Project Name: Independent Avenue Commercial Park-Prelim. Plan

REVIEW SHEET SUMMARY

ITEM INDEPENDANT AVE. COMMERCIAL PARK - PRELIMINARY DATE SENT TO REVIEW DEPT. 4-4-80

PROPOSED FIRE PROTECTION SYSTEM FOR INDEPENDENT AVE. COMMERCIAL PARK (X FIRE HYDRANTS)

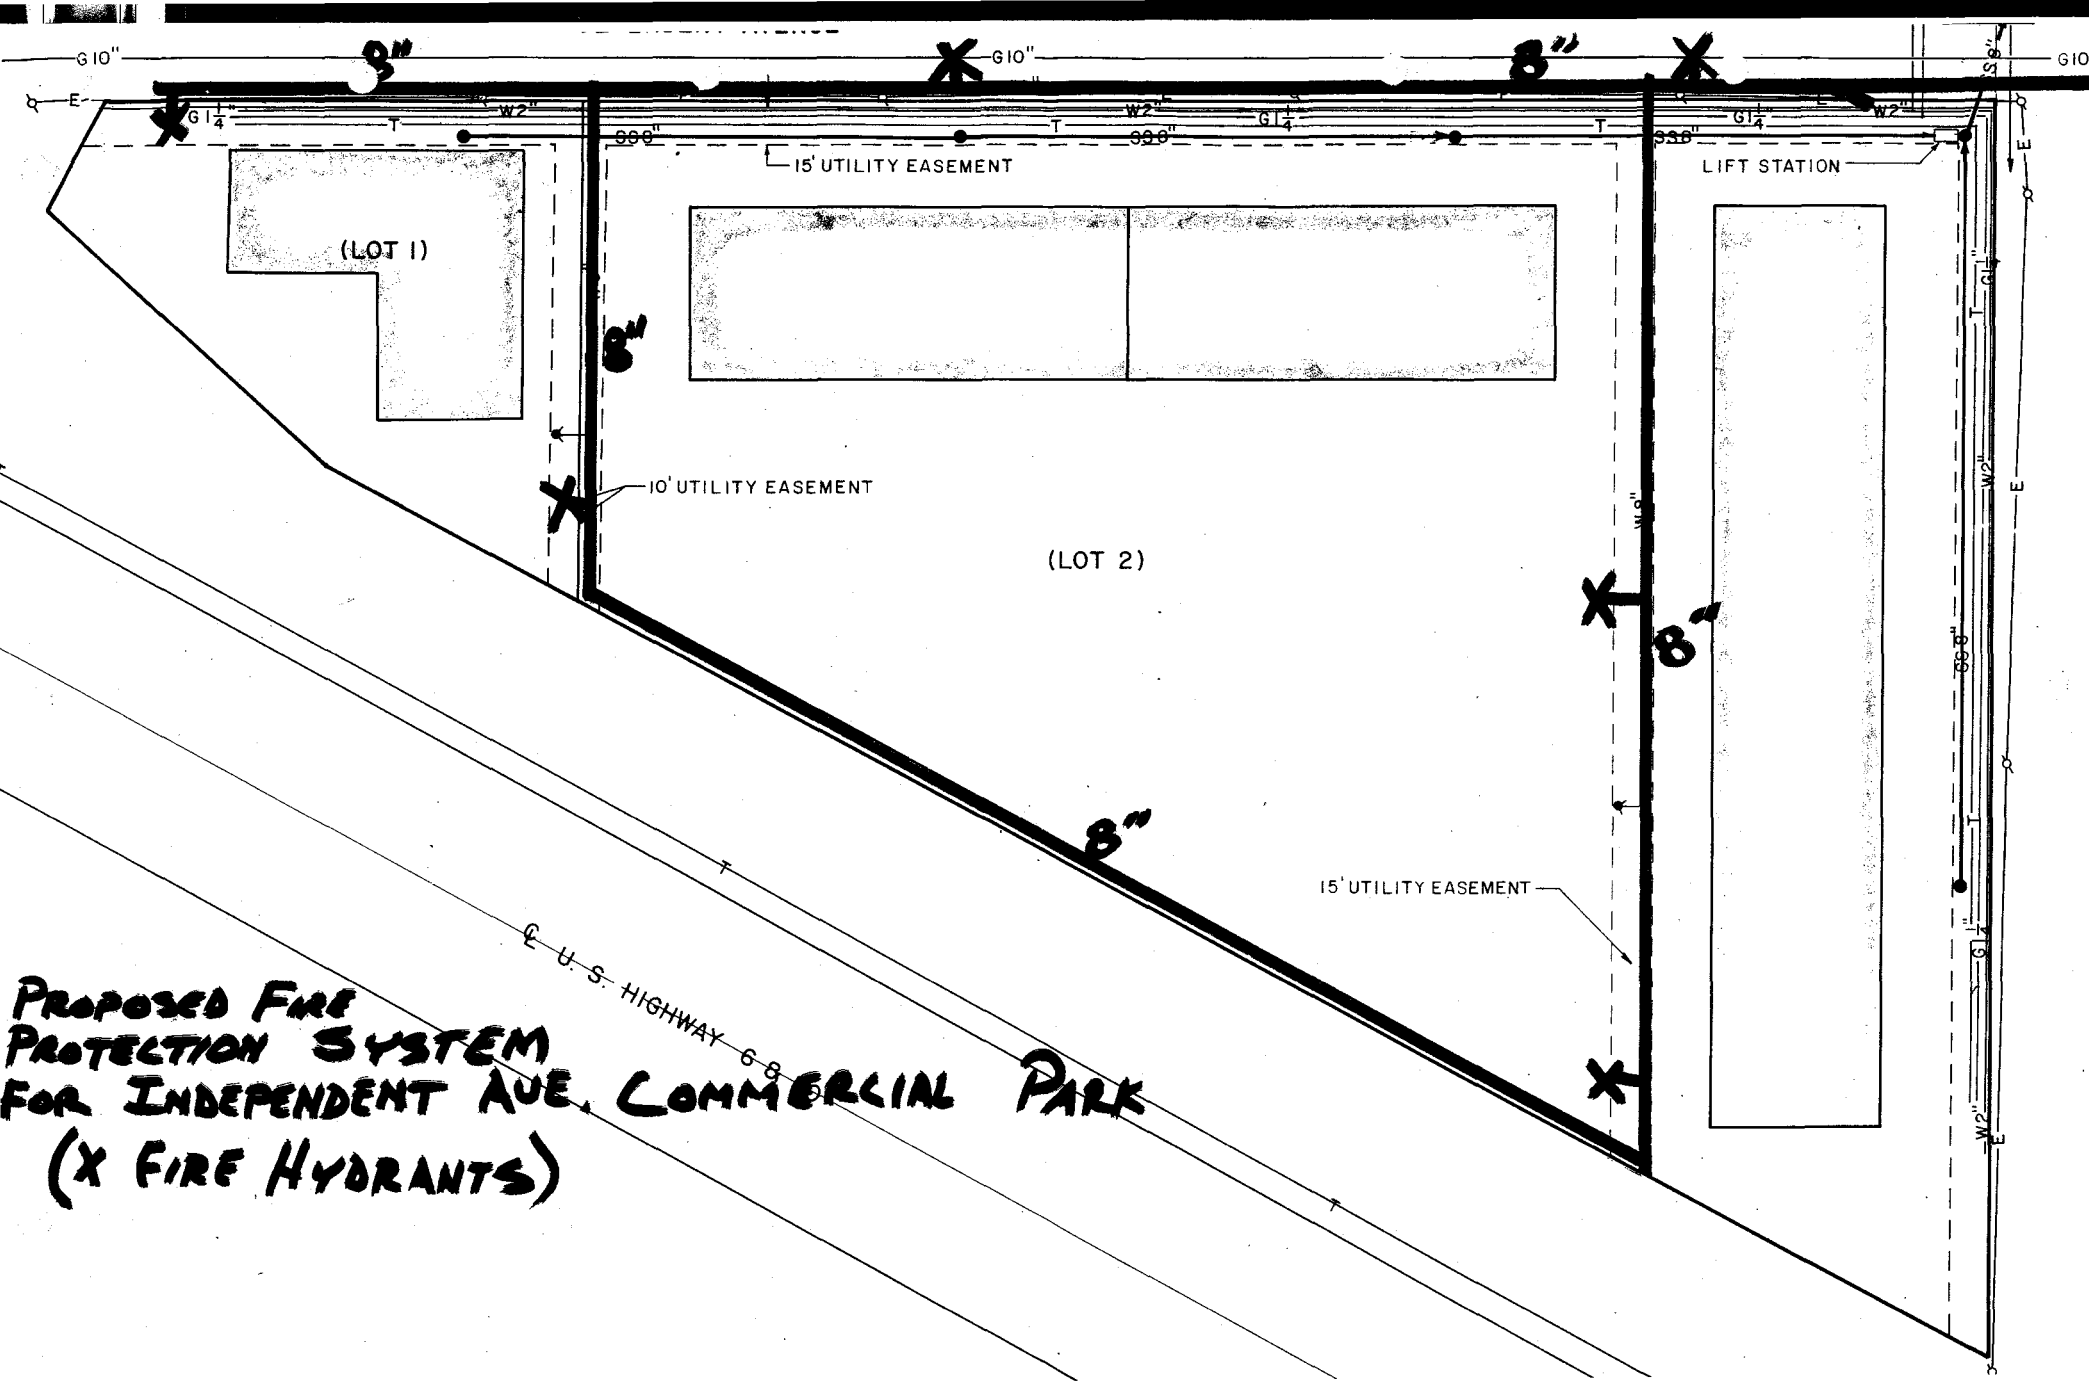
<u>DATE REC.</u>	<u>AGENCY</u>	<u>COMMENTS</u>
4-7-80	MAPPING	No objection
4-10-80	CITY UTILITIES	Sewage collection system including pump station is to be privately owned and maintained. Connection to city system allowed with payment of plant investment fee for each structure served. When Independent Ave. sewer is constructed (est. 1981), then at option of owners the pump station can be taken out of service and gravity sewer service obtained in Independent Ave. by paying tap fee (less plant investment fees) for each structure served. Fire protection water lines and fire hydrants to be built to city specifications and maintained by city. Domestic water to be provided by Ute District.
4-11-80	CITY FIRE	Water for fire protection for this development is most likely inadequate as it is being supplied off of a dead end 2" Ute line. For this type of development it is reccomended that a minimum 8" looped line be used. Seven (7) hydrants will be required as follows: <ol style="list-style-type: none">1. N.E. corner Lot 22. 300' west of hydrant #13. 300' west of hydrant #24. 300' south and west along property line from hydrant #35. 300' south along east property line Lot #26. 150' south of north property line of Lot #2 in the 15' utility easement and at least 40' away from any structure (city water is close-if annexed to city)7. located an equal distance between hydrant #5 and hydrant #6 We reccomend that just west of hydrant #3 that the 8" line be tied into the two inch line in Independent Ave. in order to provide some type of a looped system. Hydrants #5,6, & 7 should be on a minimum 8" looped line.

On the "Review Sheet Summary" file No. 26-80, you recommended a system that included seven fire hydrants, three of which were placed on an 8 inch looped line. In our conversation, I described a system of six fire hydrants, four of which were placed on an 8 inch looped line, that I feel is at least equal to your recommendation. The attached sketch shows the system I proposed.

This letter is to confirm the agreement that we made over the telephone on April 29, 1980 regarding the fire protection for Independent Avenue Commercial Park.
